Access Compliance Report

Public Rights-of-Way

(Curb Ramps)

Intersection ID: 14553	Main Street: BRIAR_CREEK_RD	Cross Street: MONROE_RD	Location: NE
ADA ID: AF1298C4188B	Ramp Type: Perp	Initial Pass/Fail: Fail	Overall Compliance: No
		Severity Score: 22.5

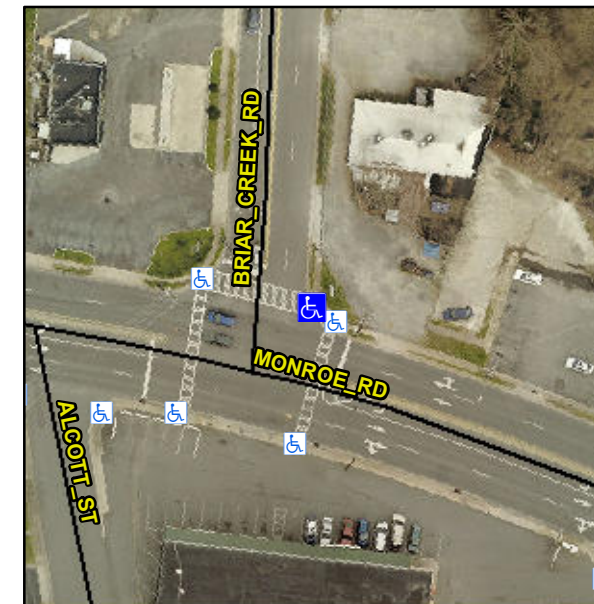
Not Found, R304.5.1, R304.2.2

Compliance	Description	Data	Compliance	Description	Data
N/A	Ramp Length (in)	64.0	No	Ramp Slope (%)	10.6
No	Ramp Width (in)	41.0	Yes	Ramp XSlope (%)	2.4
N/A	Flare Type LT	N/A	N/A	Flare Type RT	N/A
N/A	Flare Slope LT (%)	N/A	N/A	Flare Slope RT (%)	N/A
N/A	Flare Traversable LT?	N/A	N/A	Flare Traversable RT?	N/A
N/A	Landing Length (in)	N/A	N/A	DWS Provided?	N/A
N/A	Landing Width (in)	N/A	N/A	DWS Contrast?	N/A
N/A	Landing Slope (%)	N/A	N/A	DWS Length (in)	N/A
N/A	Landing X Slope (%)	N/A	N/A	DWS Full Width?	N/A
N/A	Landing Curb? (Y/N)	N/A	N/A	DWS Offset (in)	N/A
N/A	Shared Landing?	N/A			
N/A	Gutter Ponding?	N/A	N/A	Gutter Slope (%)	N/A
N/A	Gutter Lip Ht (in)	N/A	N/A	Gutter X Slope (%)	N/A
N/A	Painted X Walk1?	Yes	N/A	Painted X Walk2?	N/A
	X Walk 1 Direction	To NW		X Walk 2 Direction	N/A
N/A	X Walk 1 Width (in)	115.0	N/A	X Walk 2 Width (in)	N/A
	X Walk 1 Slope (%)	3.4		X Walk 2 Slope (%)	N/A
	X Walk 1 X Slope (%)	5.8		X Walk 2 X Slope (%)	N/A

Remove & Replace Entire Ramp.
